Submission to the CNSC Public Hearing on NB Power's Application to Renew the Reactor Operating Licence for Pt. Lepreau NGS

Hearing Number Ref. 2017-H-02

Sunil Nijhawan, Ph.D. P.Eng

Figure 2 : Example of LOCA + LOECI fuel temperatures as a function of onset of fuel dryout

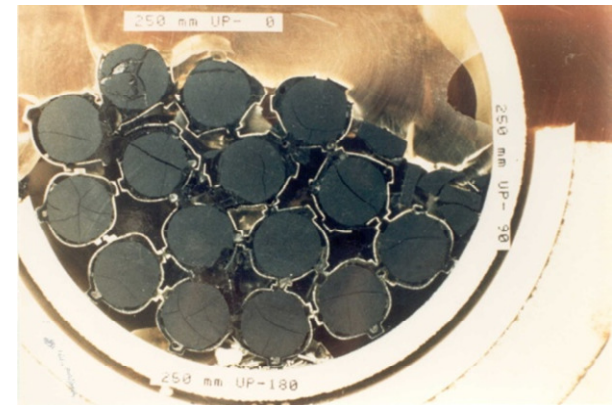
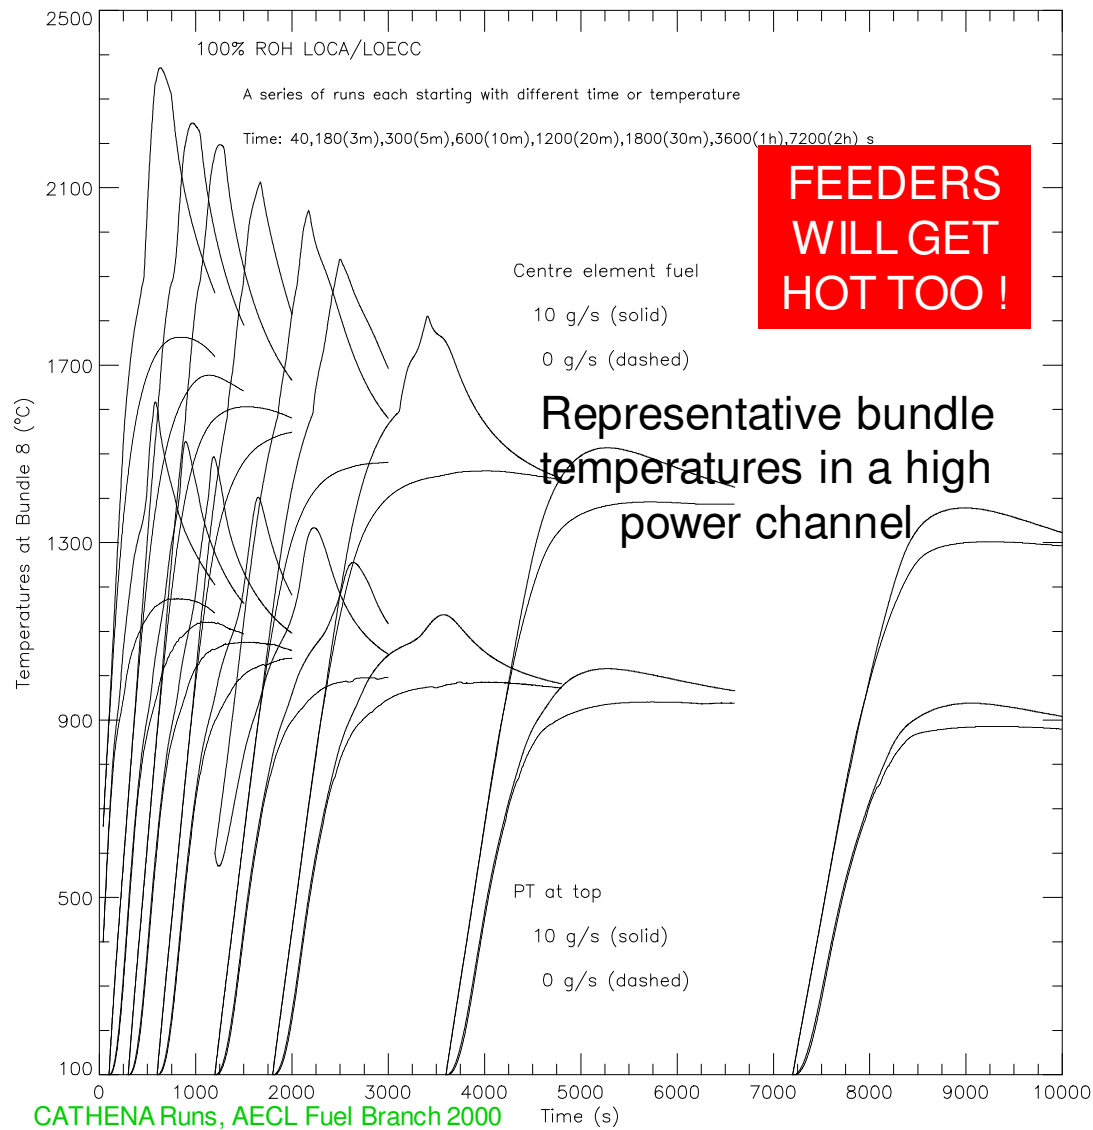
Overheating channels (Figure 2), fed by steam circulating through the heat transport system also contribute to a natural consequential heatup of downstream end fittings and feeders. Different channels void at different times depending upon their decay power and volume of water in their feeders.

Pt. Lepreau safety report will confirm to you that for larger breaks fuel bundles as well as the feeders are hotter earlier and longer as ECC fails to inject (see Figure 2). These will produce more combustible deuterium. The small (65 kg, if I recall correctly) source term ‘hydrogen’ for LOCA+LOECC in the safety reports is amusingly wrong. New Brunswick Power should amend estimates of that ‘design basis’ risk before being granted a licence extension. They should also provide a ‘hydrogen’ mitigation system

Figure 10: Sample calculations to demonstrate that Pt. Lepreau safety relief valves with 1mm lift cannot relieve enough decay heat steam (~20 kg/s) to avoid an uncontrolled rupture

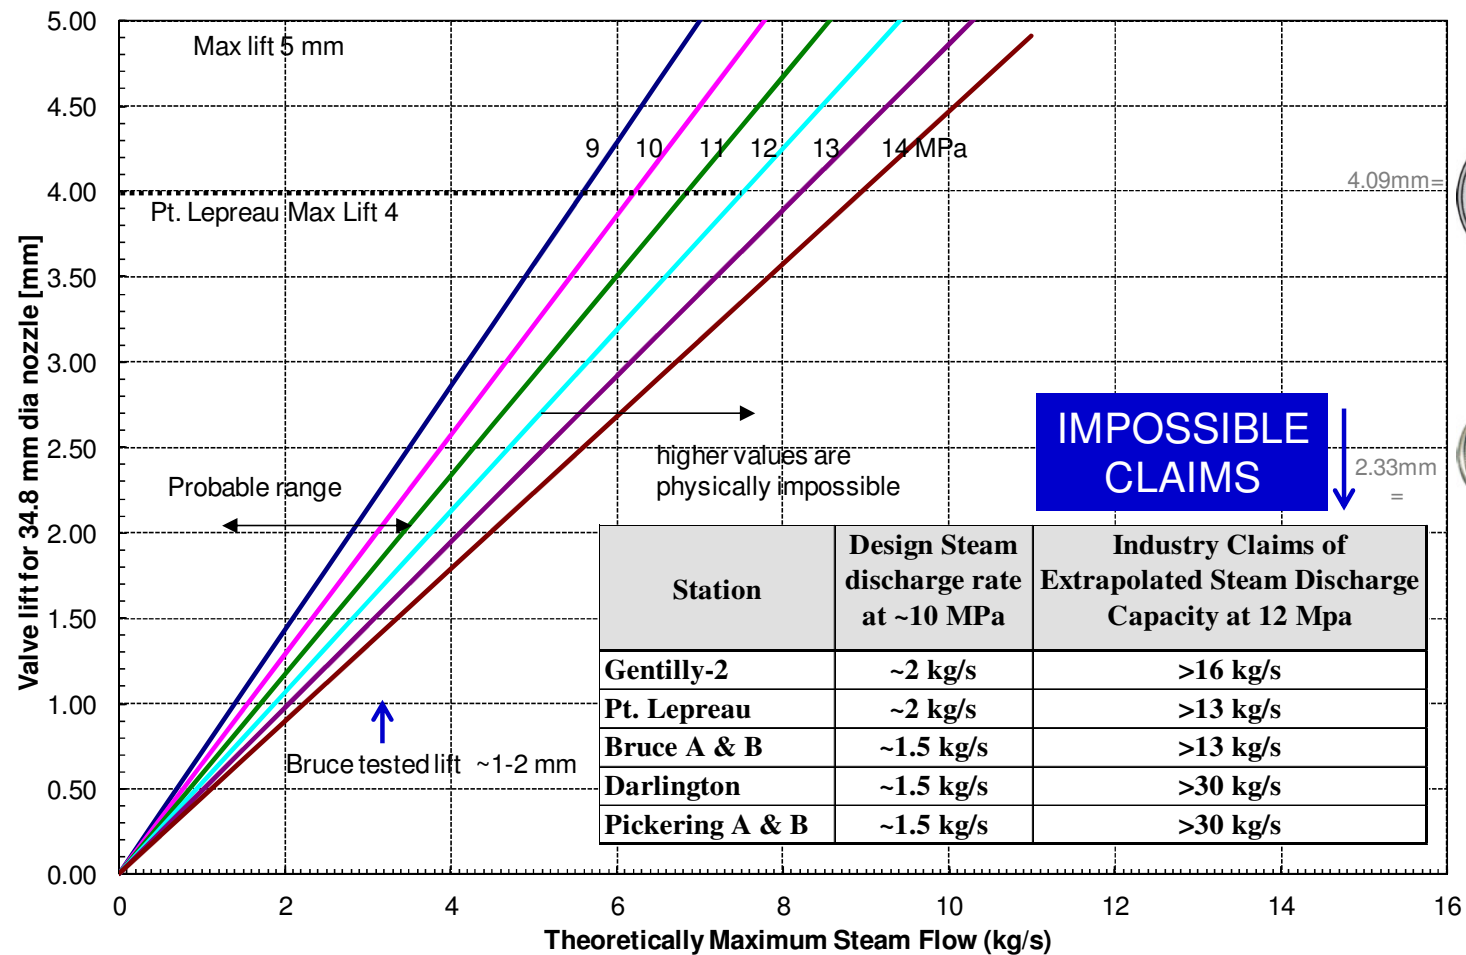
the SRVs can never discharge enough steam (Figure 10) to avoid an overpressure. It was also shown by some AECL testing at Wylie Labs & valve spring analysis that the valves cannot open fully under steam conditions (lift of about 1mm out of a total possible lift of 4mm) and thus are only able to relieve less steam than needed. A proper over pressure protection will not be available when required. This can result in an uncontrolled rupture of the pressure boundary.

Figure 11 : AECL calculations confirming that the steam relief capacity of the Pt. Lepreau type safety relief valves at <10 kg/s is inadequate and will cause uncontrolled ruptures

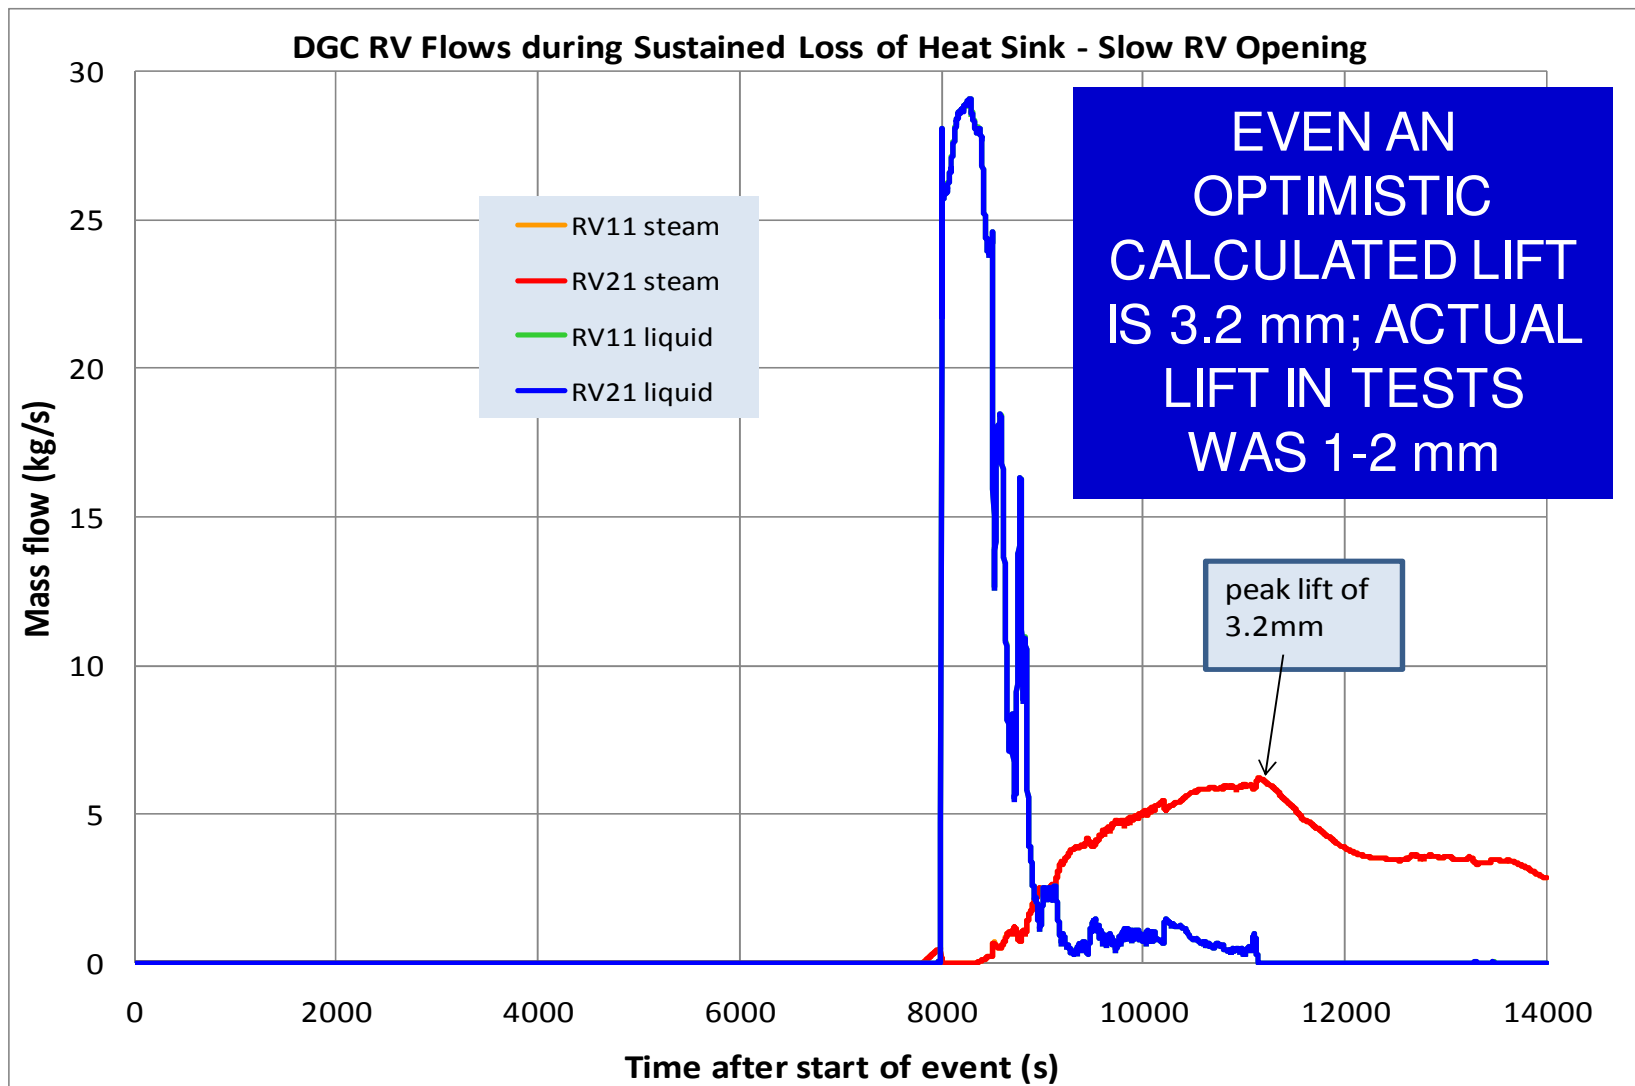
It is clear that the subject valves, replacing a properly designed valves in 1996, are ill designed for ALL CANDU reactor and their designer specified steam relief capacity of ~1.5 to 2 kg/s of steam is just not sufficient to remove energy production at the time when they are required to work. The subject Pt. Lepreau SRVs were actually designed for **liquid** relief of about 27 kg/s and a steam relief of 2 kg/s. Tests showed that these valves lift fully under liquid relief conditions but lift only partially (20%) under steam relief conditions (thrust force by steam on valve seat is significantly lower than for liquid water). The discharge area is proportional to lift and is significantly smaller for steam. This was confirmed by testing and actually an engineered valve spring feature to meet the design specifications of 1.5 to 2 kg/s of steam discharge capacity. The reactor must enhance the over protection system by installing safety relief valves that preclude a pressure boundary failure. AECL confirmed the inadequacy of the steam relief capacity (Figure 11) in analyses presented in 2011.
